**The HR Wallingford document of September 2015 entitled:**  
**“Grove Lodge, Admirals Walk**  
**Review of First Steps BIA Response”**  
**attached to and relied on in the Campbell Reith Report of October 2015**  
 **(“the WR”)**

**With reference to London Borough Camden Applications  
2015/4485/P and 2015/4555/L and the RESPONSE  
to Campbell Reith's audit of the Wallingford BIA.**

The following Appendices (**A** and **B**) have been permitted to compensate for the brevity with which technical submissions entitled *The HR Wallingford document of September 2015 entitled: "Grove Lodge, Admirals Walk Review of First Steps BIA Response"* attached to and relied on in the Campbell Reith Report of October 2015 (*"the WR"*) were required in response to the audit conducted by Campbell Reith.

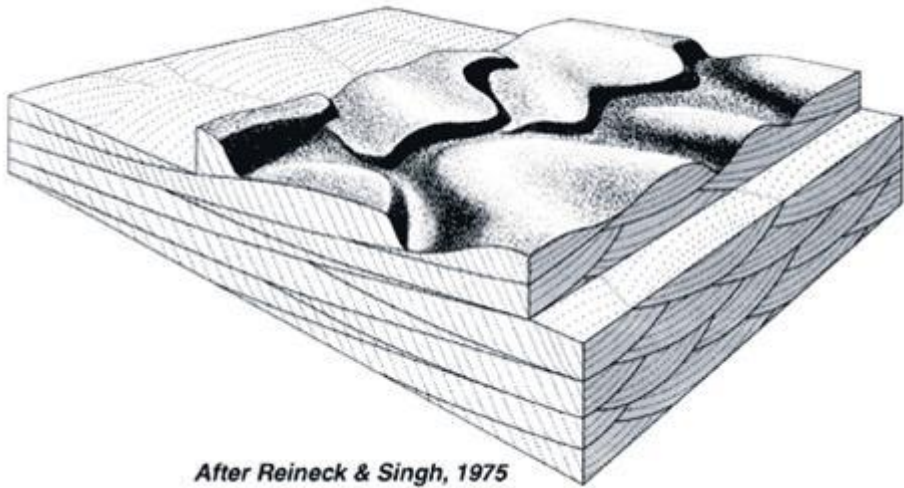
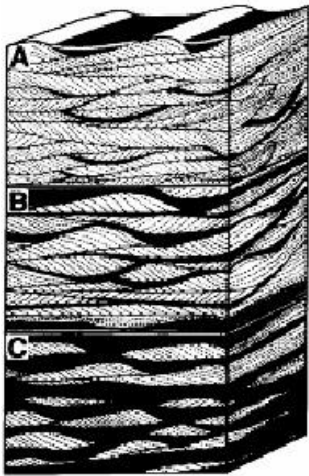
B13. In other words the design upon which this aspect of planning permission is sought is vulnerable to erosion and until the prospect of that can be eliminated the design as proposed cannot be guaranteed.
